Process Sheet

Customer : CU-DAR001 Dart Helicopters Services	Drawing Name : 350/355 AS X-TUBE FWD
Job Number : 27823	
Estimate Number : 12485	
P.O. Number : <i>N/A</i>	Part Number : D350748101
This Issue : 7/5/2006 S.O. No. : <i>N/A</i>	Drawing Number : IIN D350-748 P5 PREL <i>06.07.05</i>
Prsht Rev. : NC	Project Number : N/A
First Issue : <i>N/A</i>	Drawing Revision : PREL
Previous Run : <i>N/A</i>	Material : <i>N/A</i>
Written By : <i>[Signature]</i>	Due Date : 7/30/2006
Checked & Approved By : <i>[Signature]</i> <i>06.07.05</i>	Qty: 1 Um: Each
Comment : Est Rev A New Issue 06-07-05 JLM

Customer	: CU-DAR001 Dart Helicopters Services	Drawing Name	: X-TUBE AS 350/355 HI FWD
Job Number	: 27823A		
Estimate Number	: 12484		
P.O. Number	: N/A	Part Number	: D350748141
This Issue	: 7/5/2006	S.O. No.	: N/A
Prsht Rev.	: NC	Drawing Number	: D350-748-141 PREL
First Issue	: N/A	Project Number	: N/A
Previous Run	: N/A	Drawing Revision	: PREL
	Type : LANDING GEAR	Material	: N/A
Written By	: _____	Due Date	: 7/30/2006
Checked & Approved By	: <u>06-07-05</u>	Qty:	1 Um: Each
Comment	: Est Rev: New Issue 06-07-05 JLM

DESIGN <i>92</i>	DRAWN BY	DART AEROSPACE LTD HAWKESBURY, ONTARIO, CANADA	
CHECK

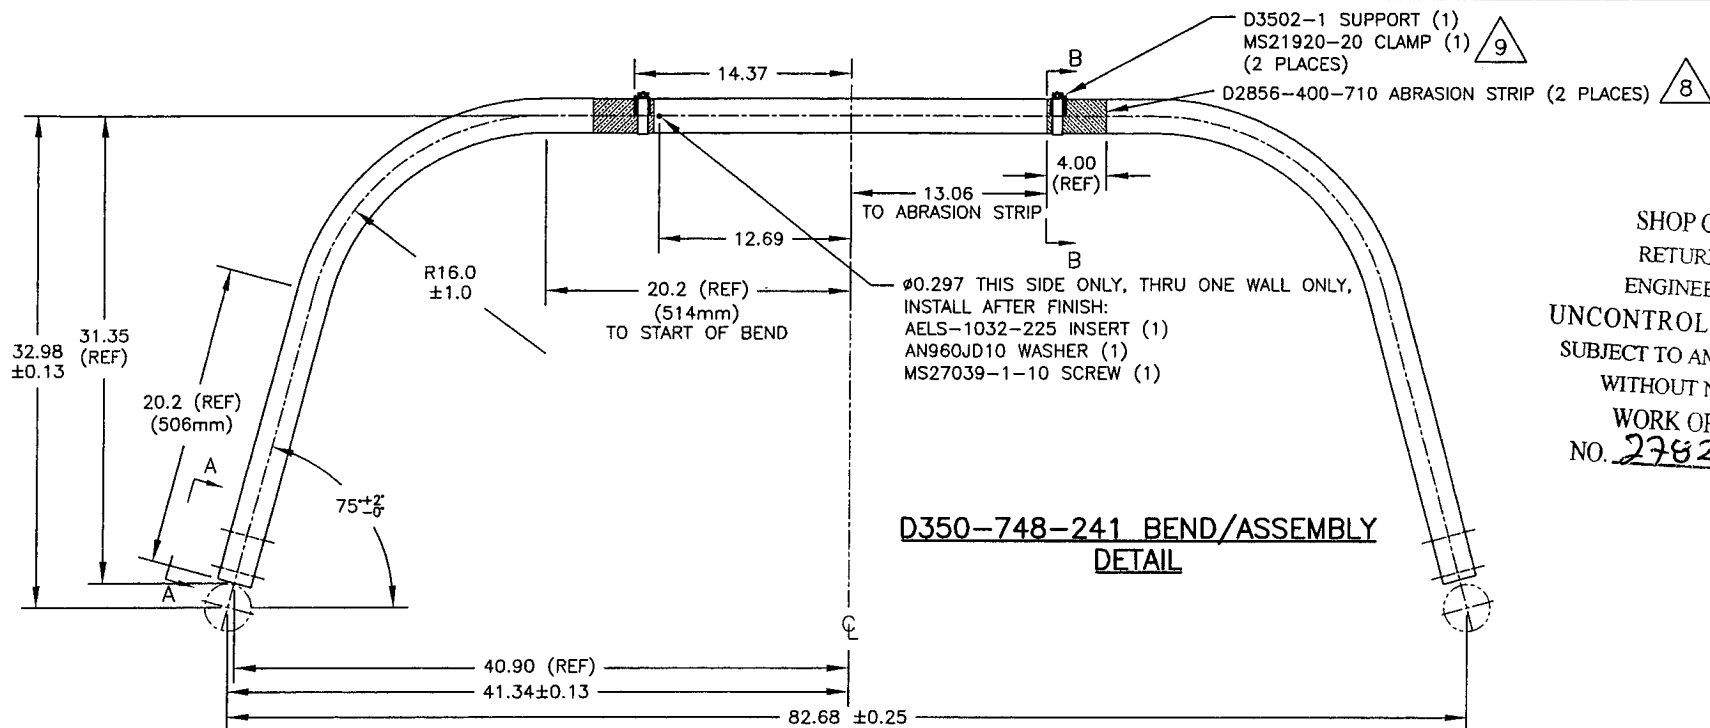
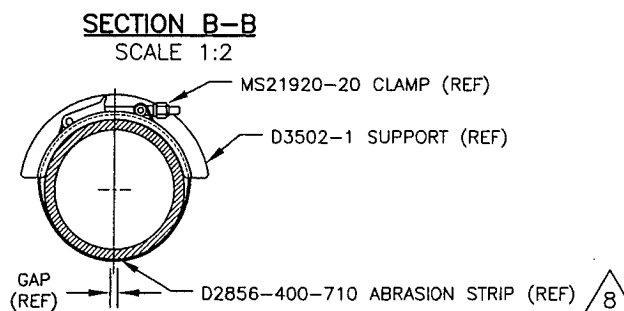
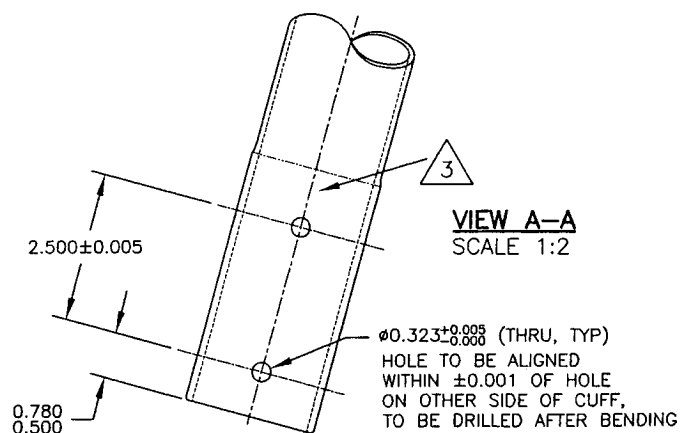
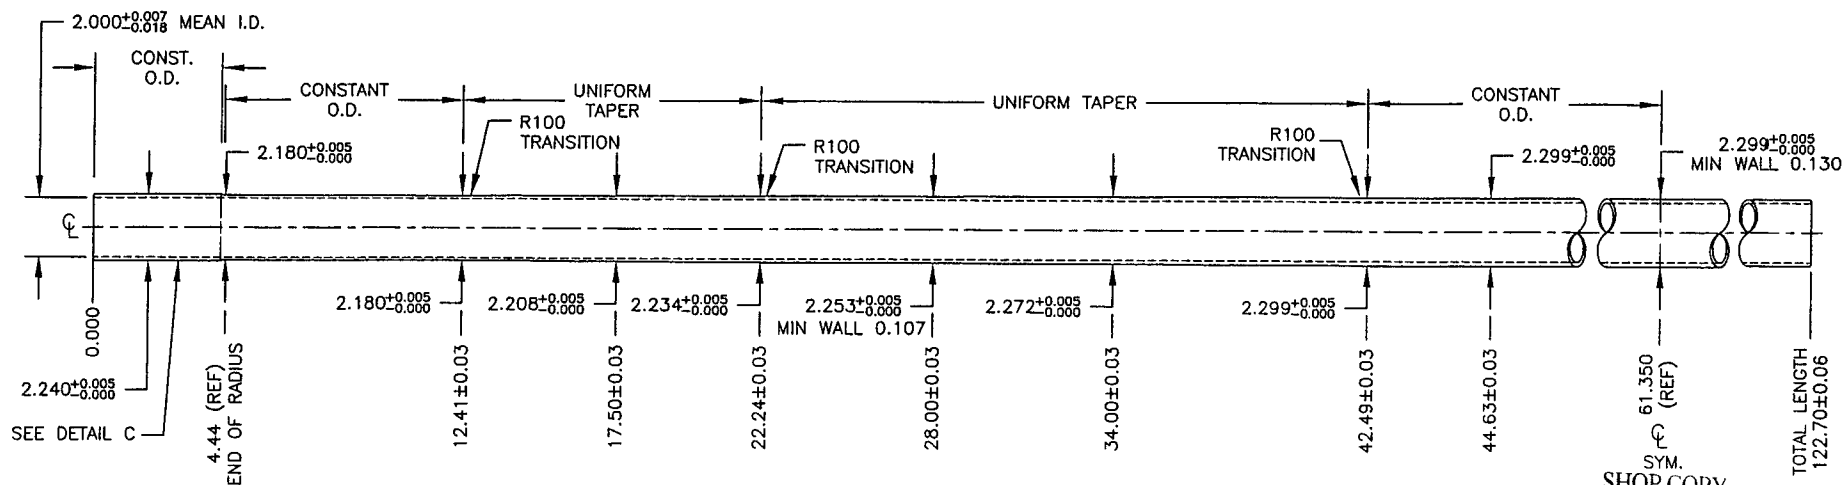
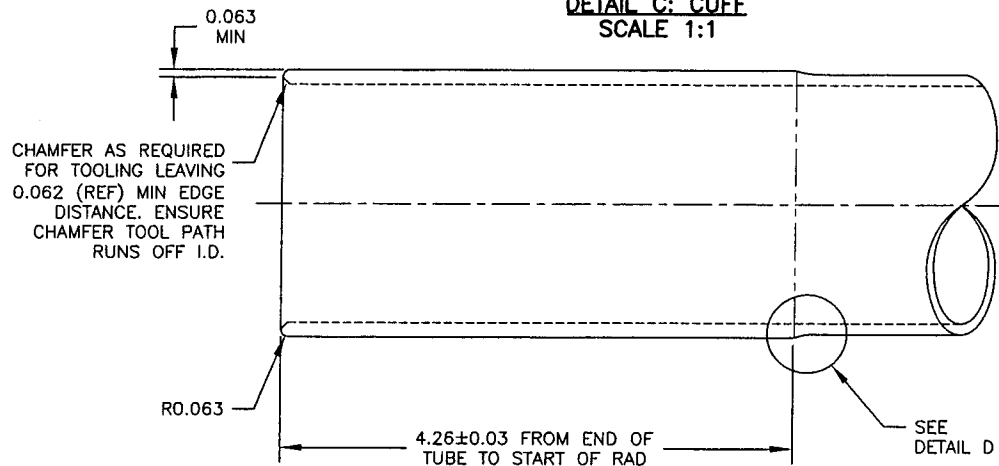
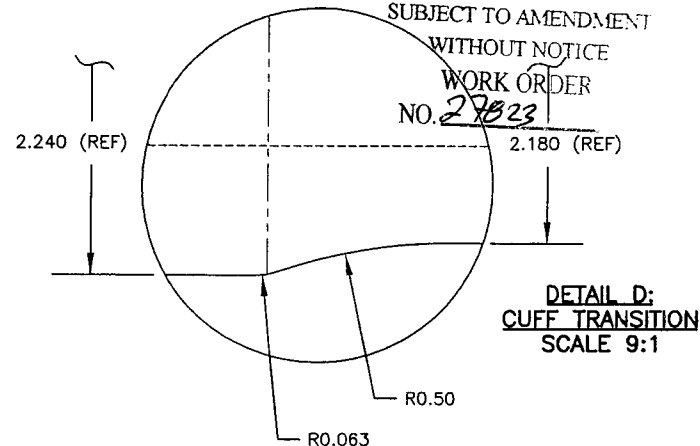
As we discussed, I had some concern about the stress relieving comment on the packing slip because I didn't realize that by heating up the tubes, we would be stress relieving them. We didn't test our crosstubes in a stress relieved condition. The crosstubes we tested had compressive stresses in the tensile stress areas of the crosstube. However, because the highest stress areas are in the unbent portion of the crosstube and because I think we had so much margin in our drop test (no shock absorbers, damaged parts, overloaded, etc ...), my gut tells me that we are OK and I don't think we need to re-test.

There is another set of 350 xtubes they want to send out tomorrow. I don't know if you've had a chance to review the cad plating issue. They're eager to get a response.

To recap:

- I originally told you that the magnetic particle was done first. That was the plan, but they ended up following the drawing (cad->magnetic). The invoice I sent you gives the correct order the work was done.

- The cad plating was done to AMS-QQ-P-416B (issued 2004 by SAE) instead of the drawing's' QQ-P-416F (issued 1991 by military). I don't see a problem with this since it's a more current issue, and the only reason specified QQ-P-416F is because that's what the "old" never-used supplier suggested.

- The dims were re-checked after cad plating and the dimensions did not change.

- An NCR has been created to address the problem with the work orders. The bigger issue is that one was sent to a customer and we need to take action on that one asap.

I think the modified CAD plating procedure is acceptable.

I'm glad to hear that we are dimensionally checking the crosstubes after all the heating. I think this step should be added to the work order on receiving inspection for every crosstube.

As we discussed, I think a drawing revision is in order. I think reference to a QSI for the procedure outlined on the packing slip would be best.
